**BELL BEND NUCLEAR POWER PLANT
PARTIAL RESPONSE TO RAI No. 79
AND REQUEST FOR EXTENSION
BNP-2010-085 Docket No. 52-039**

Response to NRC Request for Additional Information No. 79
Questions 03.08.04-3, 03.08.04-7, 03.08.04-10, 03.08.04-11, 03.08.04-12, 03.08.04-18,
3.08.04-21, 03.08.04-23, 03.08.04-24
Bell Bend Nuclear Power Plant

TYPICAL CONCRETE ENCASED
DUCT BANK CONSTRUCTION

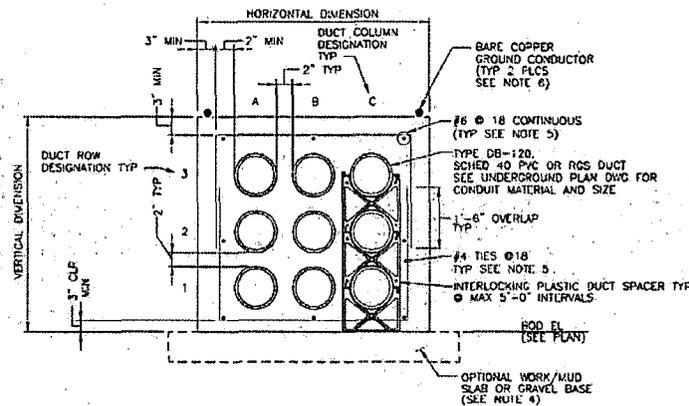
- Describe the concrete duct bank enclosures, and show typical reinforcing steel details and other relevant information.
- In BBNPP COL FSAR, Subsection 3.7.3.12, ASCE 4-98 is listed as a reference. In the BBNPP COL FSAR the publication date of this document is mistakenly listed to be 1986 and the document is referred as ASCE, 1986. ASCE 4-98 was published in 1999 not 1986. Correct this mistake.

- Class 1E duct bank is an engineered design, which is typically square or rectangular concrete enclosure. PVC conduits are embedded inside the enclosure. However, conduit containing cables sensitive to electrical noise may be rigid galvanized steel (RGS) for the entire run. A typical enclosure cross section, including its reinforcement is shown below:

**FIGURE 1-1
BOUNDARY CONDITIONS OF THE GT-STRUDL MODEL**

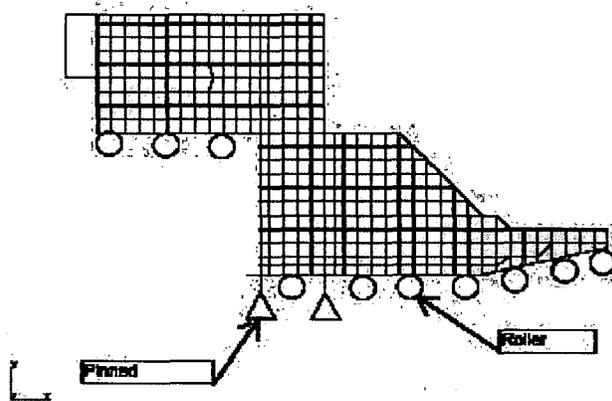
Explain what boundary conditions are assumed for these two finite element models. Is there any soil spring assumed in the boundary conditions?

Subsection 3.8.4.4.7 of BBNPP COL FSAR, Revision 0 referred to Figure 3E.4-1 and Figure 3E.4-2 which are now Figure 3E-1 and Figure 3E-2 in BBNPP COL FSAR, Revision 2. Boundary conditions for supporting elements are demonstrated in the figure below and consistent w/ the description in FSAR 3.7.2.1.2, which stated in-part as follows:

"The basemat founded on concrete back fill is modeled as roller supports. The building shear keys which are embedded in the Mahantango foundation, are modeled as hinged supports. The supporting media below the apron base is modeled as roller supports."

As shown on Figure 1-1, pinned (hinged) and roller supports were used to idealize the ESWEMS pumphouse founded on concrete backfill and/or on top of Mahantango formation. The soil springs were not used given the rigidity of the concrete backfill and/or Mahantango formation. Hence, rigid supports are considered appropriate.
